TECHNICAL SERVICE BULLETIN # 2023-6

Cleervision Windshield

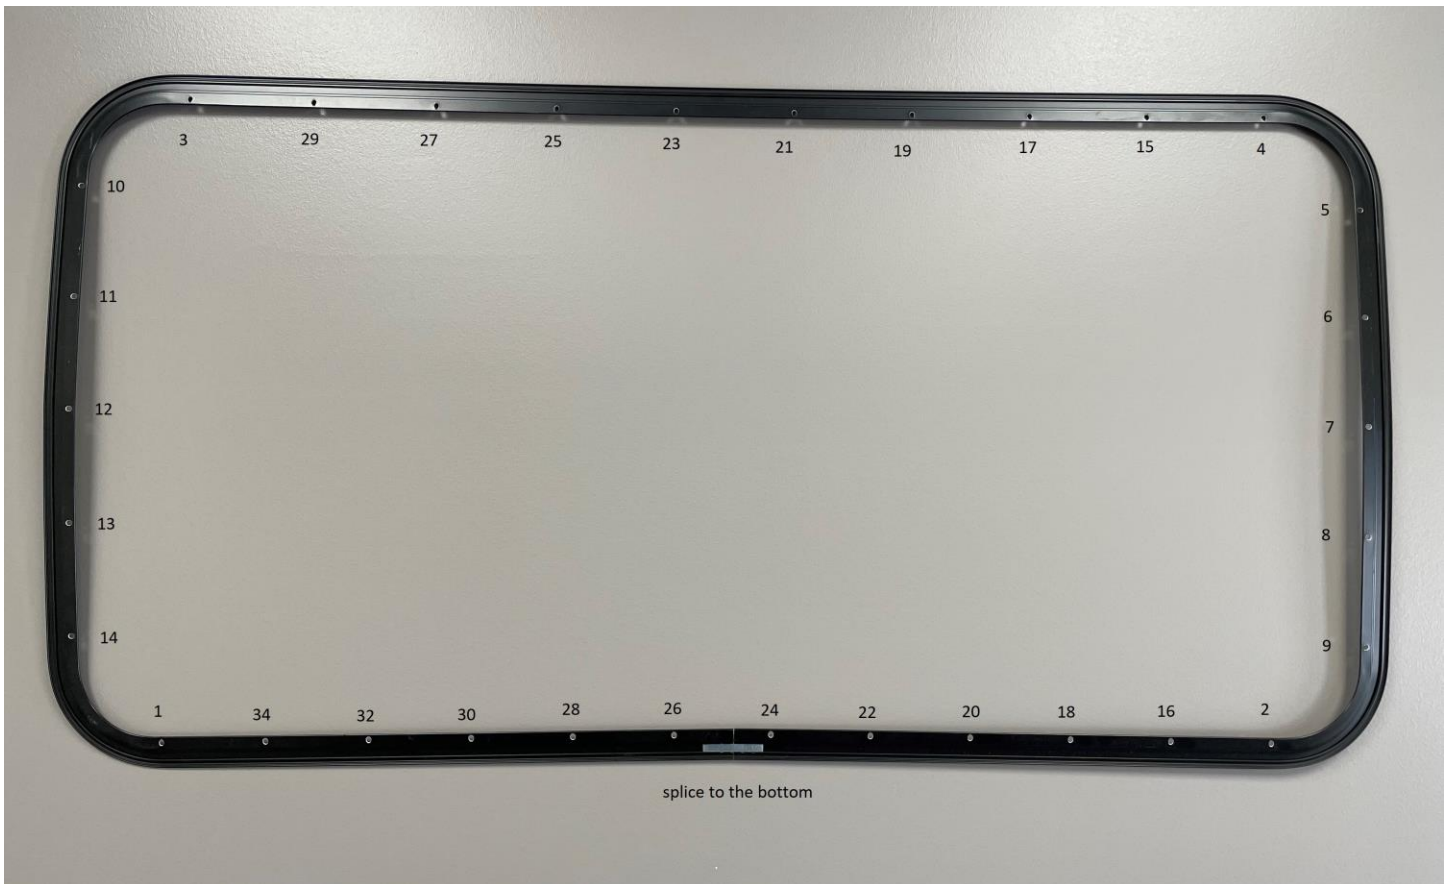
Determine that you have a Cleervision windshield by using a tape measure to measure the interior trim ring. See photos:

Cleervision measures 2 1/2" from glass to ring.

Statewide measures 2" from glass to ring.

Replacement of the Cleervision windshield:
Remove the valance, shade, and windshield.
